CONSTRUCTION DOCUMENTS FOR THE:
SUMMIT CHURCH
275 W 5TH AVENUE
EUGENE OREGON 97401

FIRE SPRINKLER PIPING PLAN
FP.1
SHEET 1 OF 1

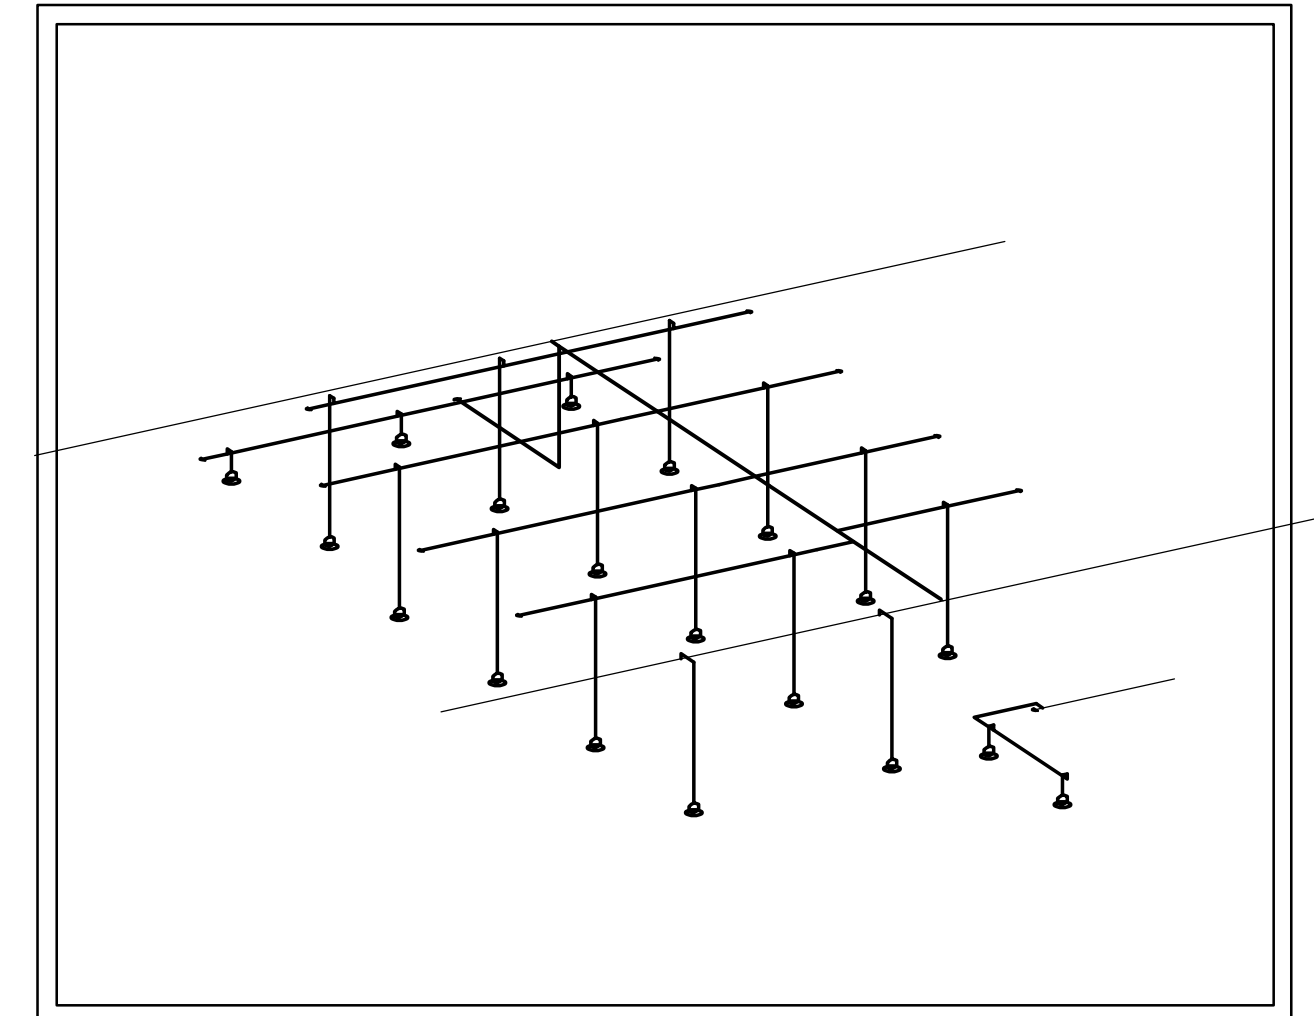
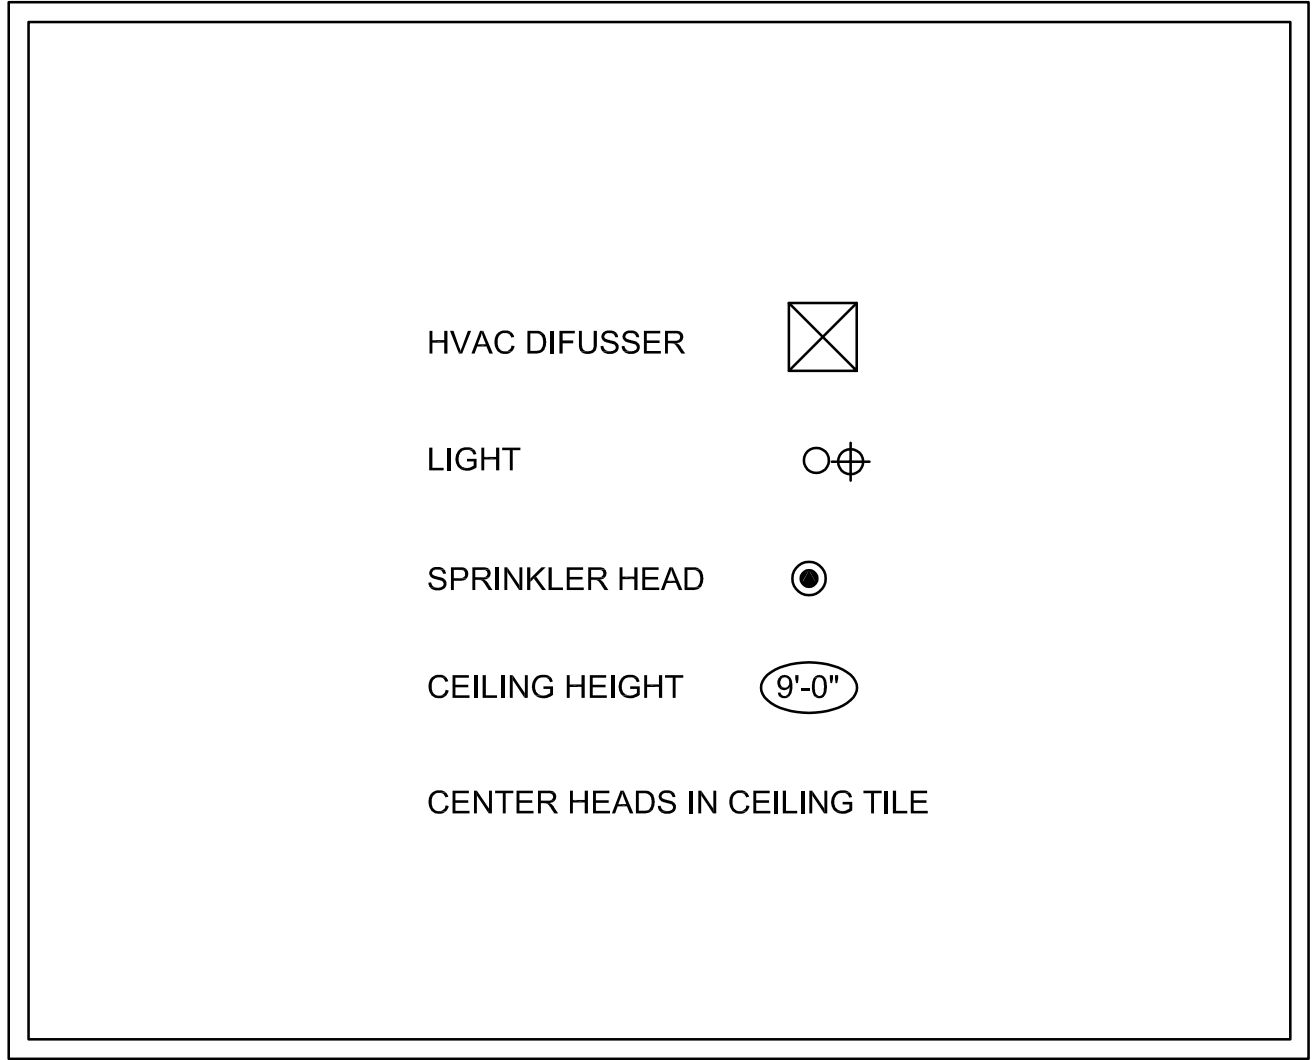
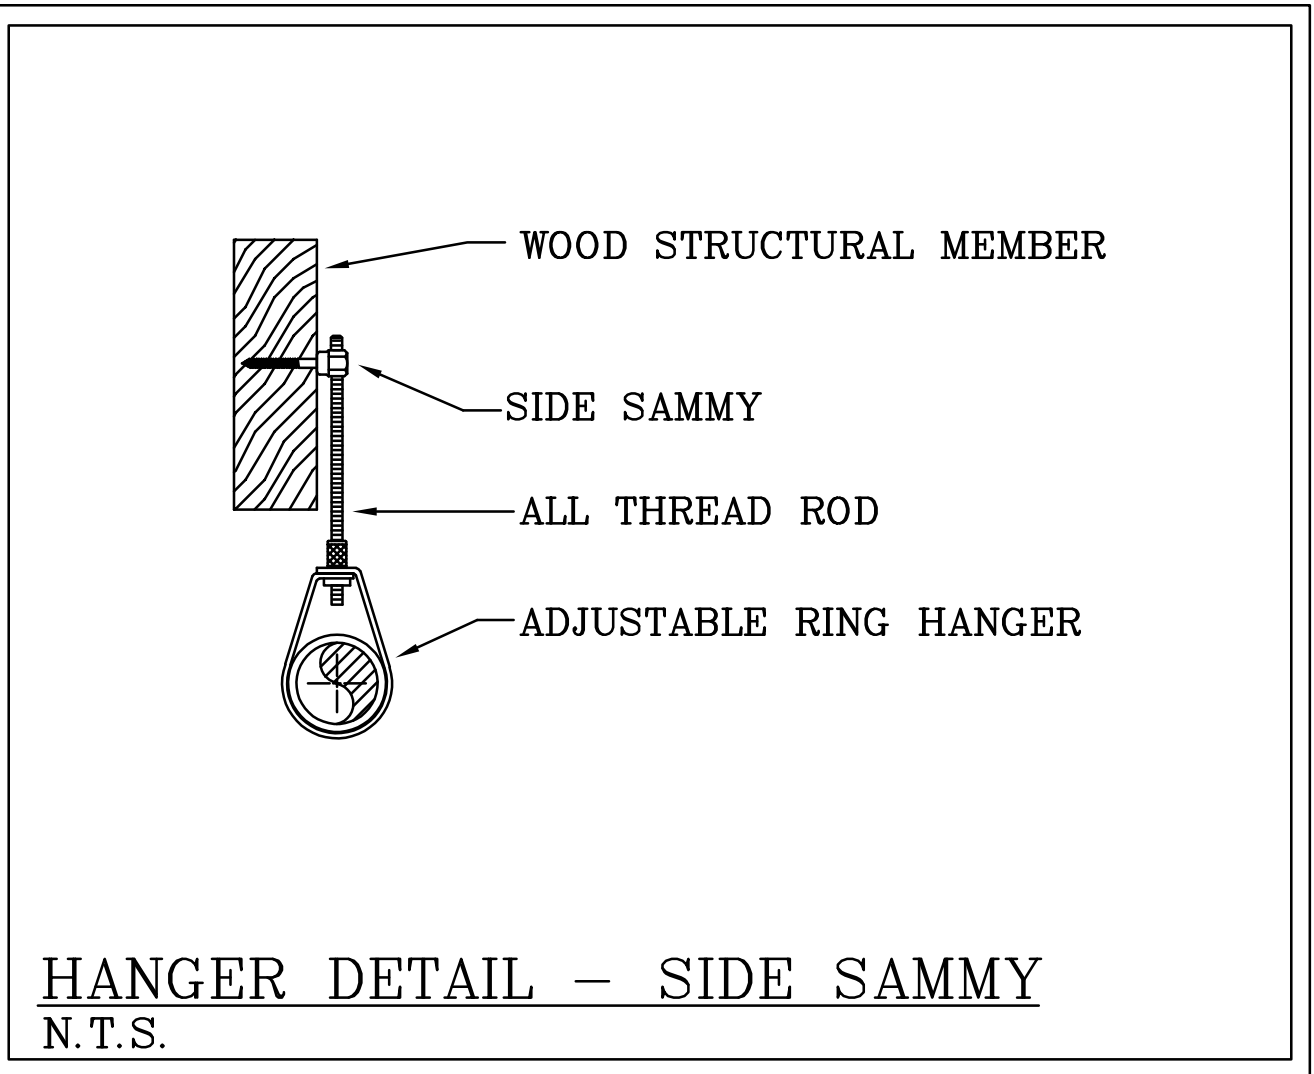
Return bends are required from dry systems per 7.2.2(3) NFPA 13. It looks like the line diagram detail shows this so this is just a note
